Symptoms exhibited by version 2 AMY chips.

1) Abbreviated History

5) Logic changes necessary to make the chip usable.

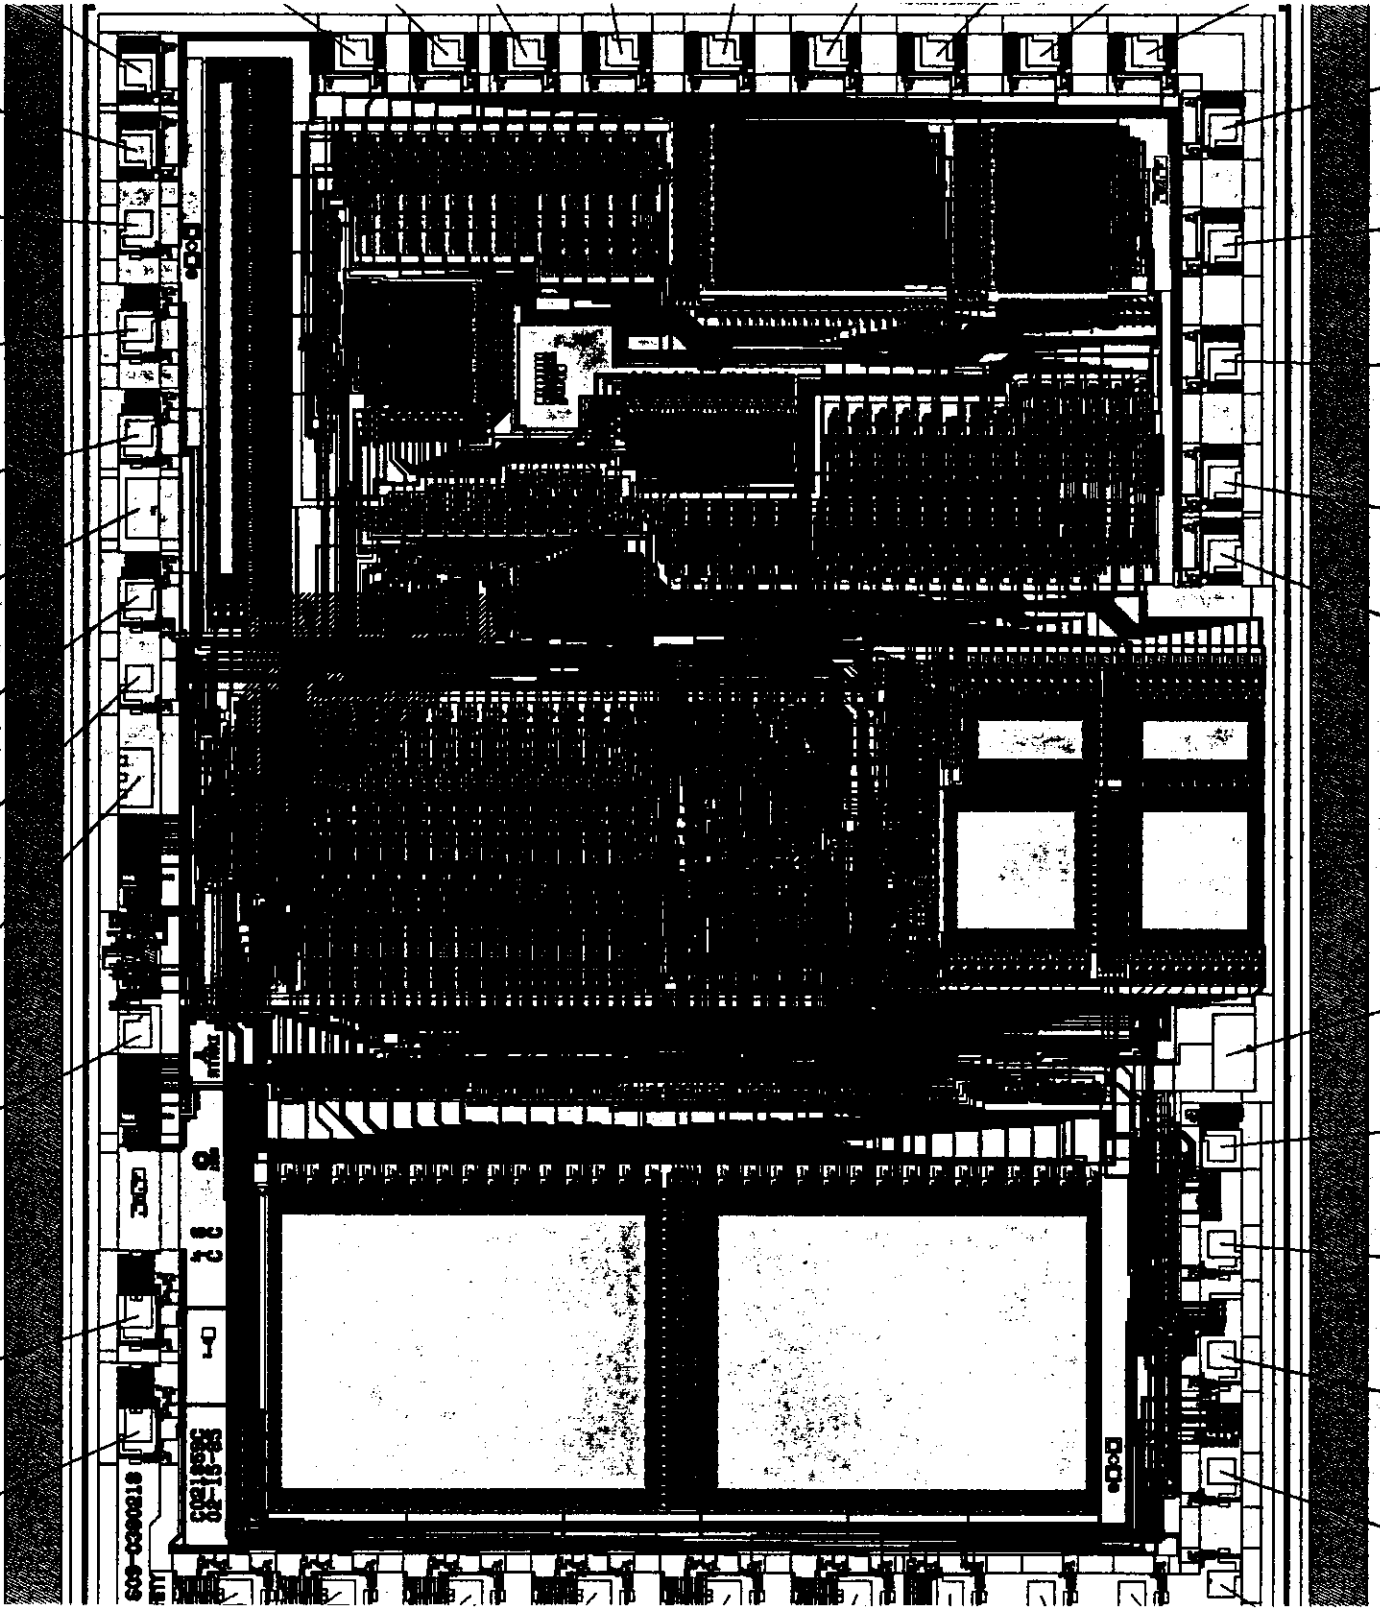
50. Commands from the host processor must be synchronized with the internal uses of the chip's bus to avoid the malfunction observed in version 2. This is accomplished by adding some gates and a delay latch.

ORIGINAL ↗

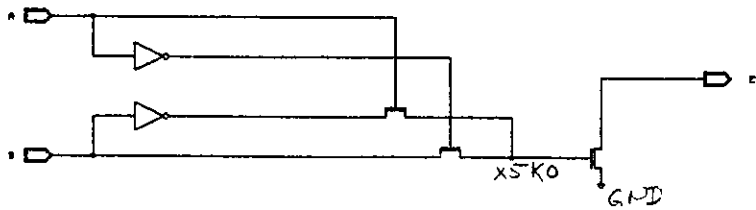
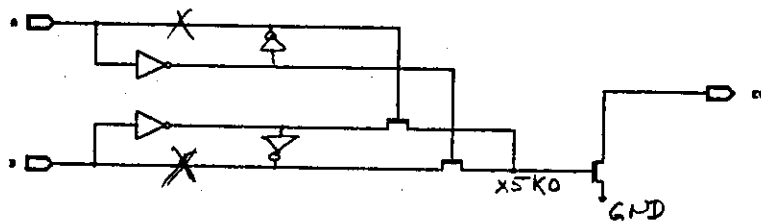
Problem: if A is unknown then
SILOS models both transistors as ON
and result is unknown.

Patch:

NOTES:	ATARI A.S.G.
KAKU/BERSID	ANY - CNTR CELL
DATE: 8/9/83	
DATE: 6/28/84	
DATE: 7-18-84 JP	
	SHEET 26 OF 32 REV A

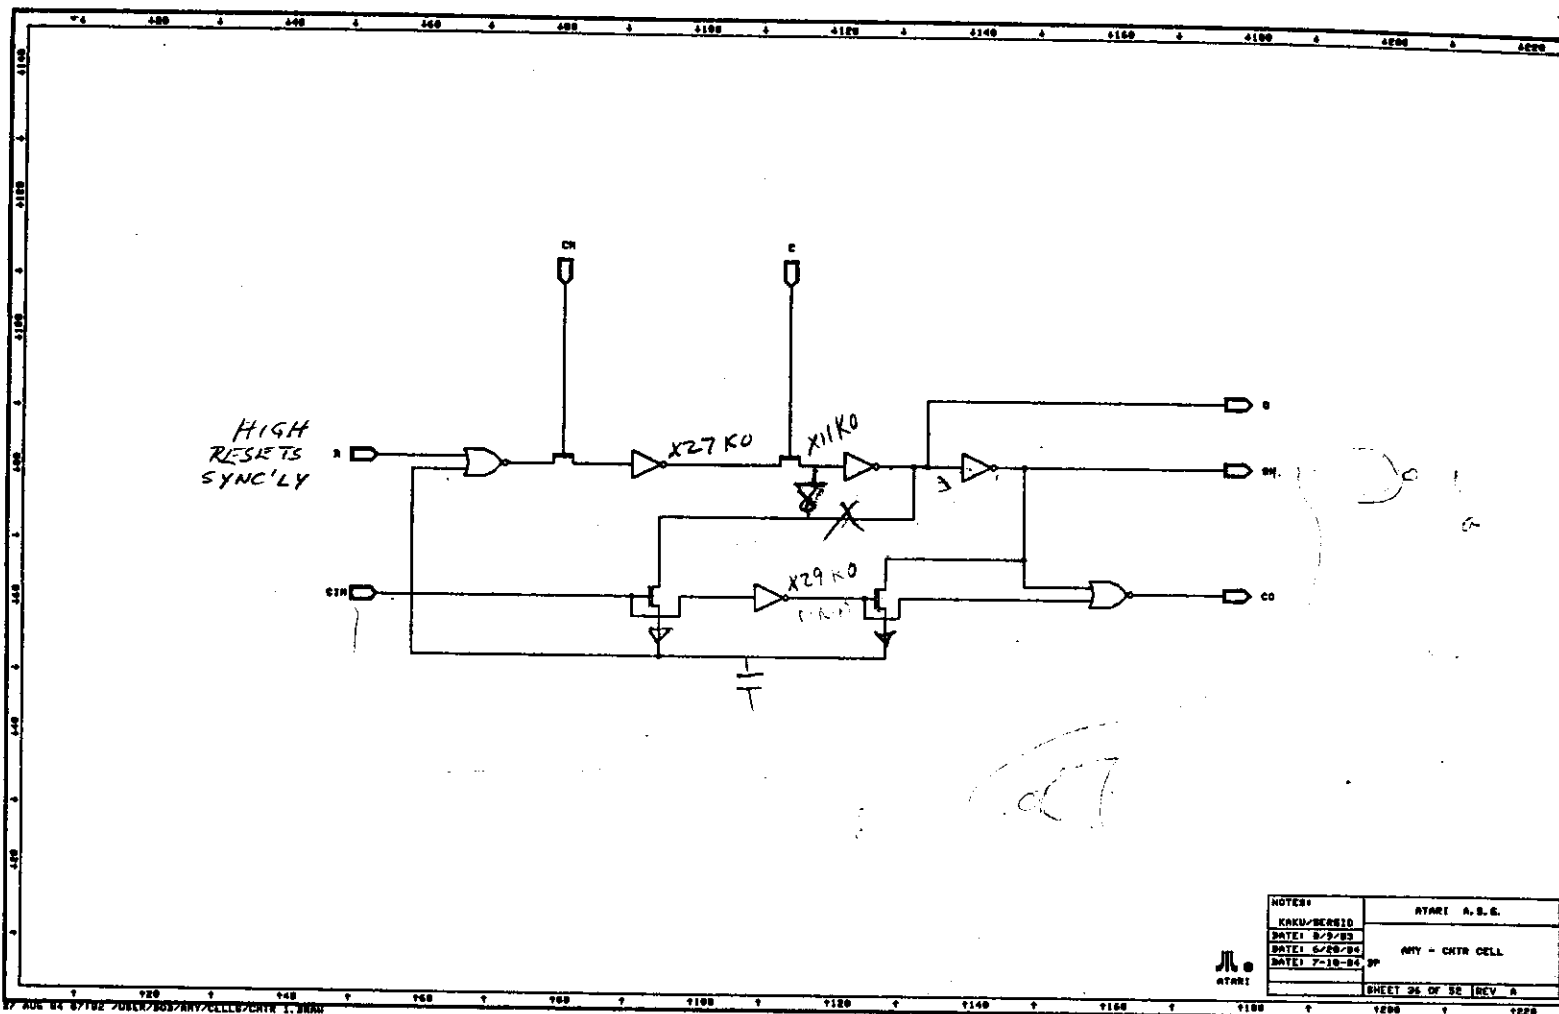
30. A special version of the counter cell was inserted into the SILOS net list for the least significant bit of the voice counter. With the cell really present in the silicon the SILOS simulation enters into an oscillation with the feedback used to stop the voice counter at its maximum value. One chip was microprobed and the oscillation was not present (at least while the probe was loading the circuit). Furthermore no change was heard in the audio output when the probe contacted the chip and we have no observed problems that seem related to such hypothetical oscillations.
